Fire Safe Regulations Updates

**Nevada County Department of Public Works
Nevada County Fire Marshal's Office
December 2019**

COUNTY OF NEVADA DEPARTMENT OF PUBLIC WORKS	
LOCAL RURAL ROAD SYSTEM	
STANDARD STREET AND STOP SIGN	
Approved by: <i>Patth Perlo</i> Principal Civil Engineer	12-17-19 Date
STANDARD DRAWING A-5

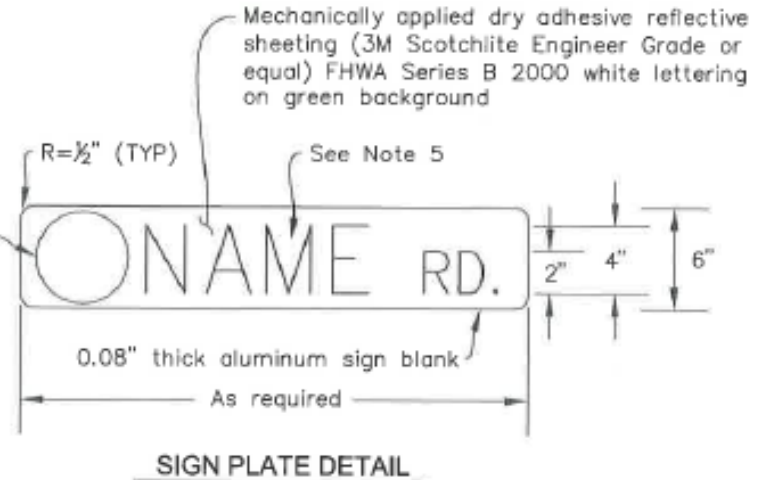
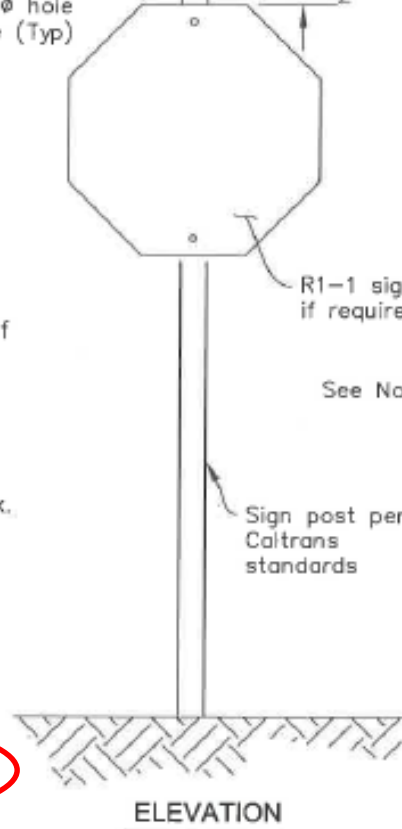
- New standards for address identification to facilitate easier location of sites during emergency response
 - Larger address numbering
 - More visible sign placement
 - Maintenance of address signage
- Corrected typos and code and standard drawing references
- Removed two standard drawings from Code section which were no longer relevant

Added

LOCAL RURAL ROAD SYSTEM
 FIRE STANDARD DRIVEWAY

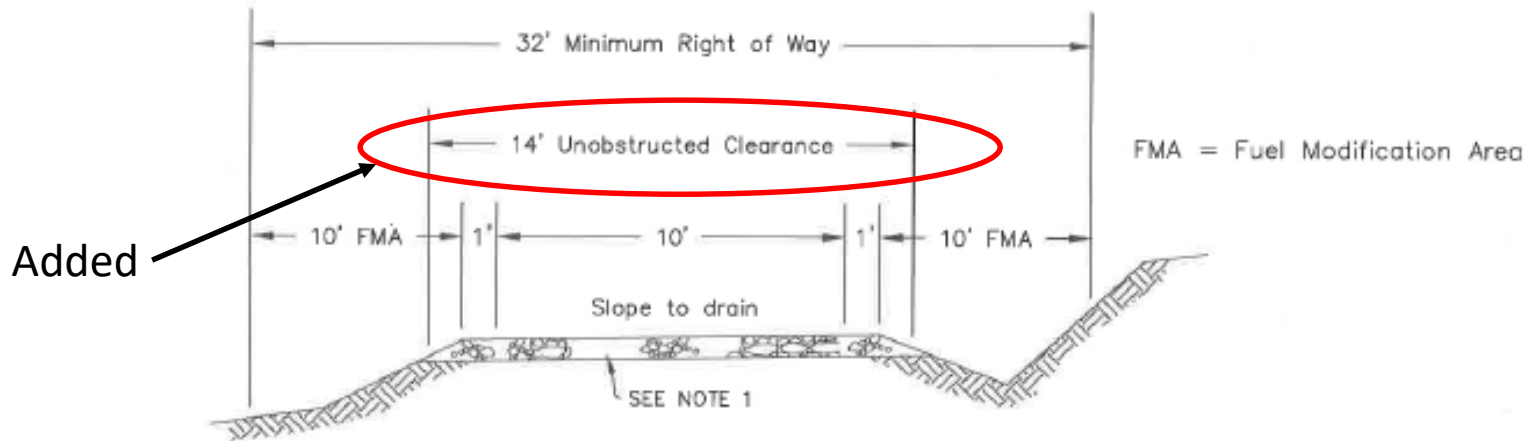
- Updates to definitions consistent with SRA Fire Safe Regs
- Driveway standards updated
 - Wider turnouts (10 to 12') with taper
 - Additional width on larger radii
 - Paved driveway encroachments clarified
 - Removed 3 drawings no longer relevant

LOCAL RURAL ROAD SYSTEM
**FIRE STANDARD
ACCESS ROAD**

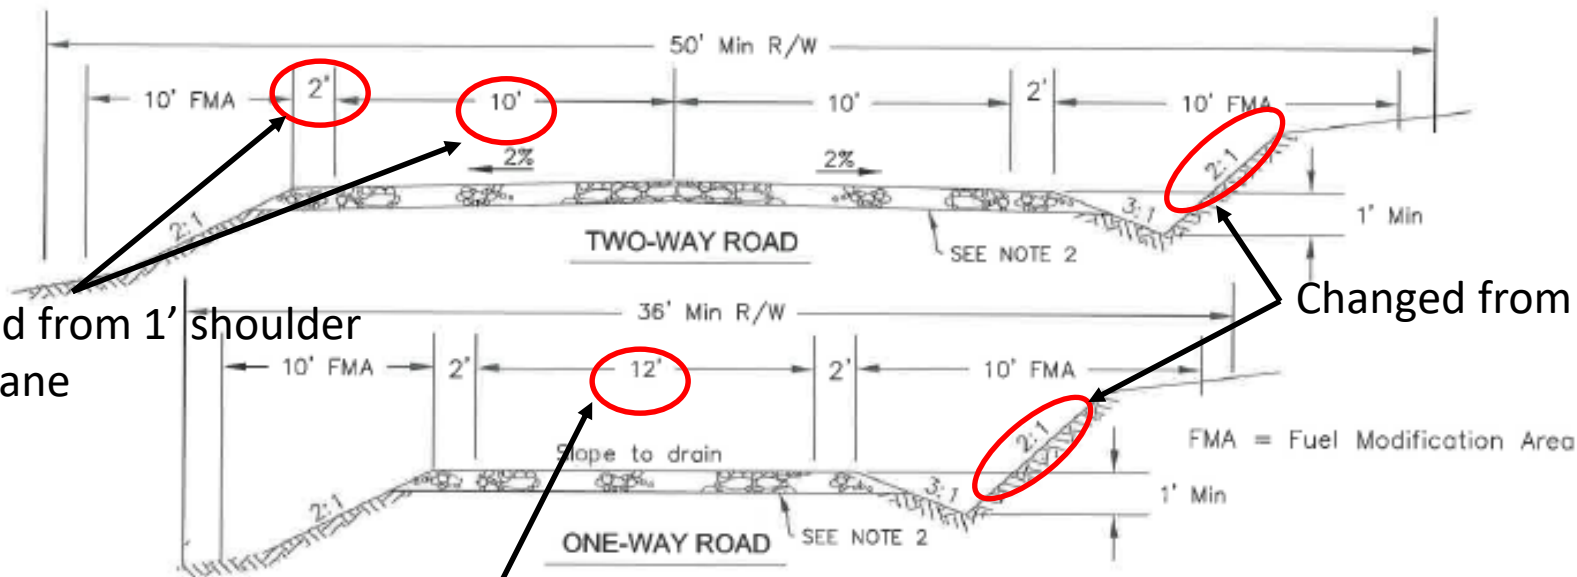
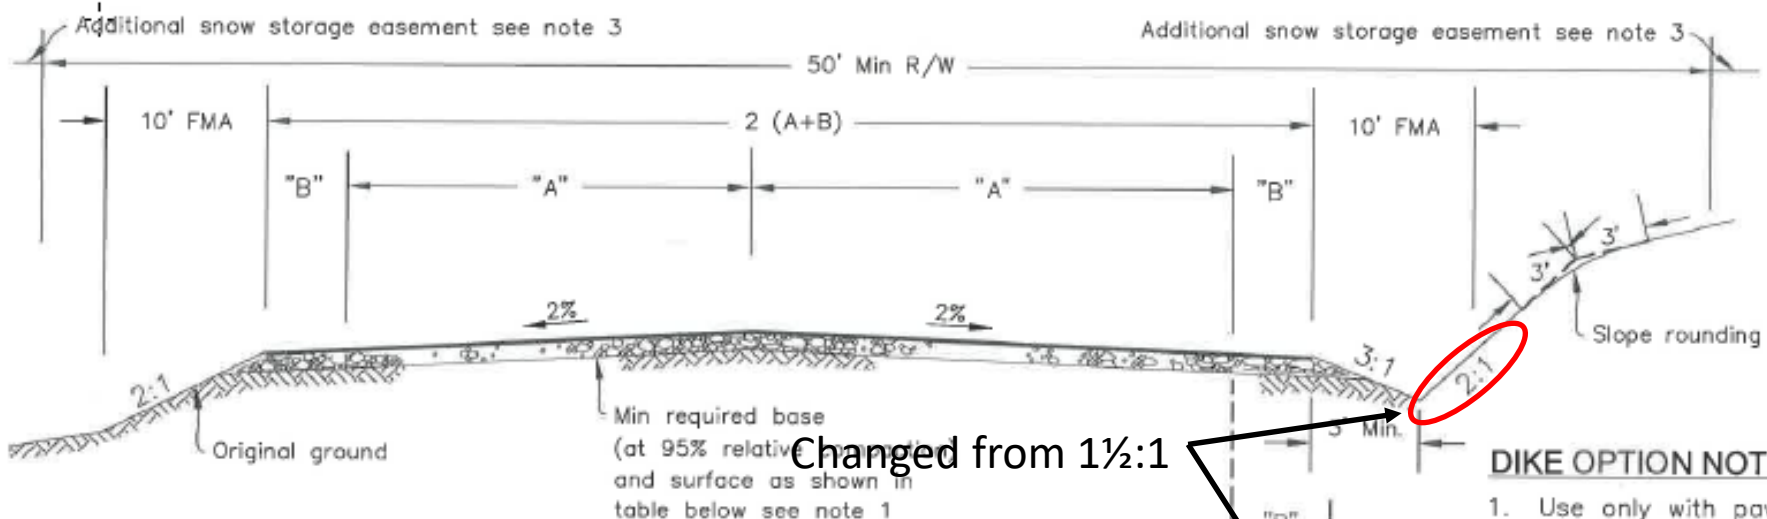
Changed from 1' shoulder and 9' lane

Changed from 1½:1

Changed from 10'

New notes

COUNTY OF NEVADA
DEPARTMENT OF PUBLIC WORKS
LOCAL RURAL ROAD SYSTEM
LOCAL CLASS 1 & 2 ROAD

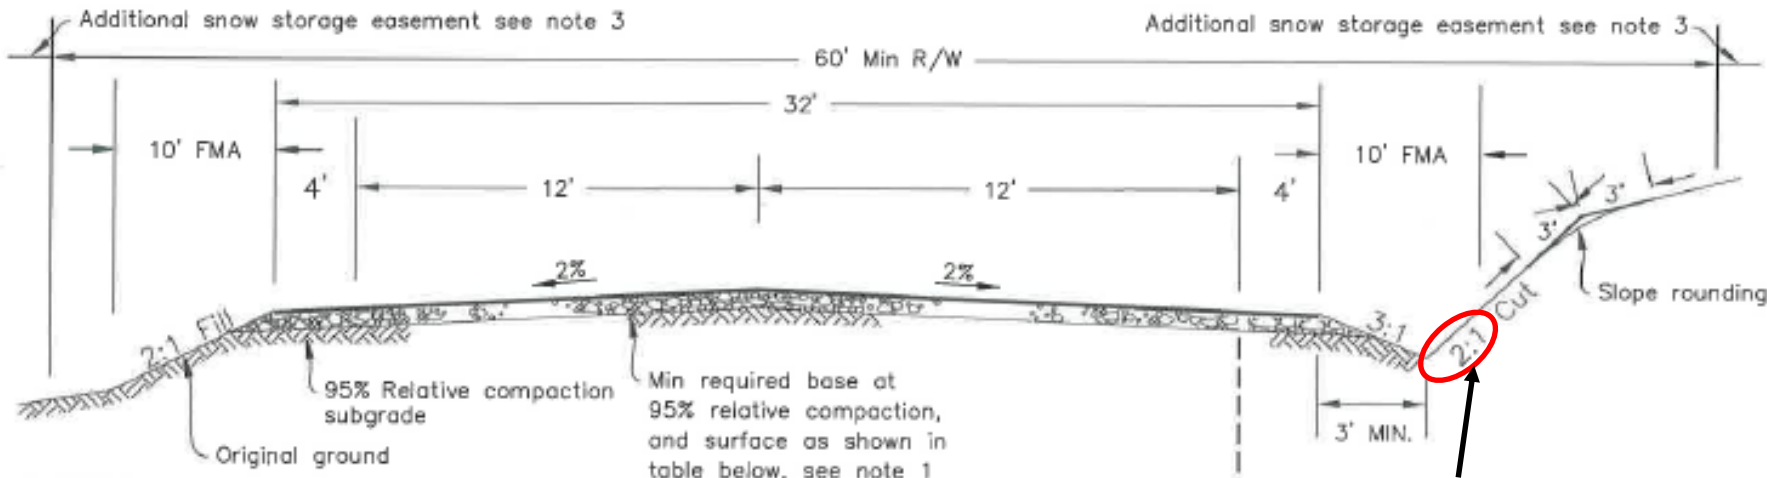
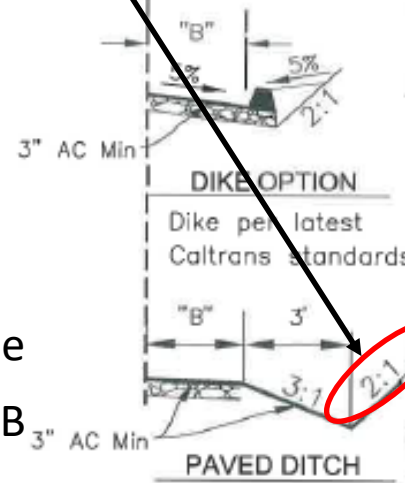
Changed from 1½:1

Changed from Chip Seal, 4" AB, 9' lane

Changed from 6" AB

Changed from 6" AB, 9' lane

LOCAL RURAL ROAD SYSTEM
MINOR COLLECTOR AND
LOCAL CLASS 3 ROAD

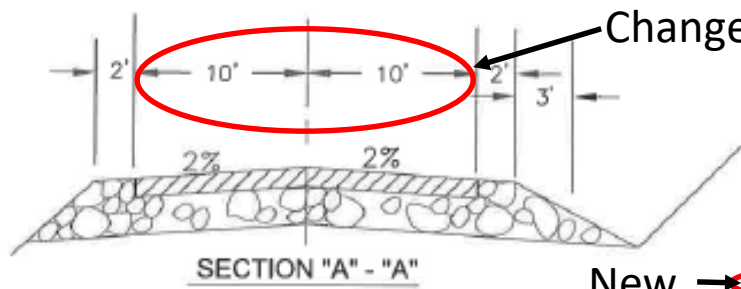
Changed from 2" AC and 6" AB

Changed from 1½:1

Changed from 9' lanes

COUNTY OF NEVADA
DEPARTMENT OF PUBLIC WORKS
ENCROACHMENTS
PRIVATE ROAD APPROACH

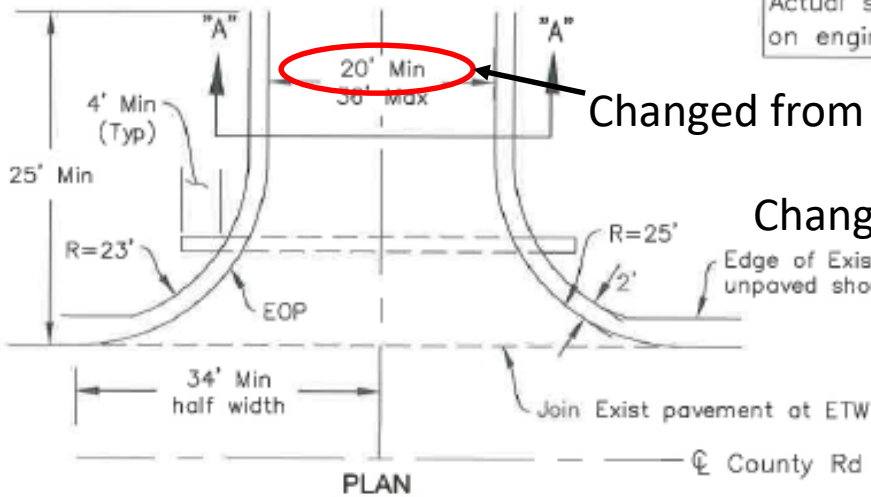
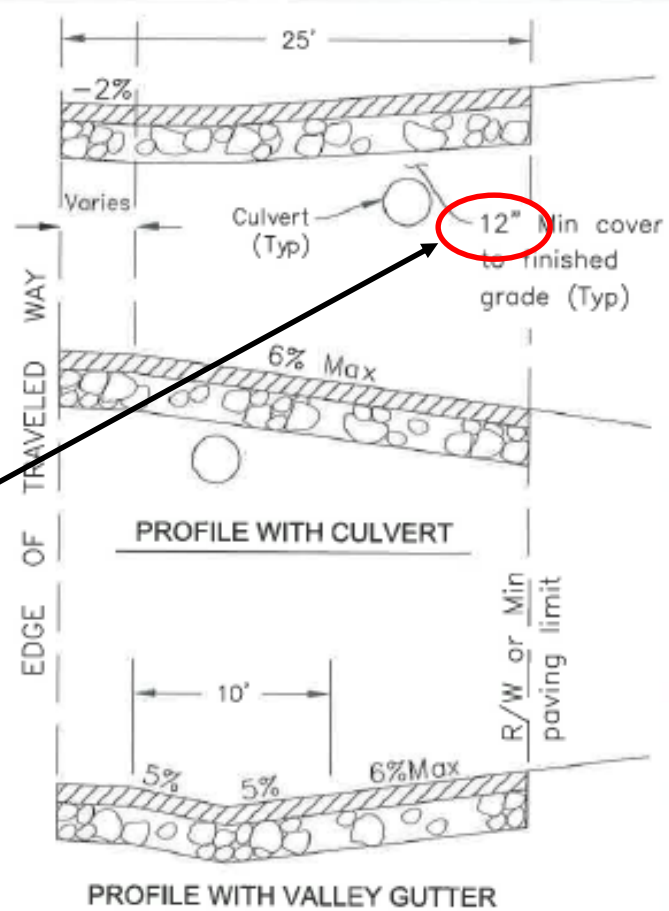
New → All pipe shall be new HDPE.
Actual size will be dependent on engineering analysis.

New

Changed from 18' min

Changed from 9" min
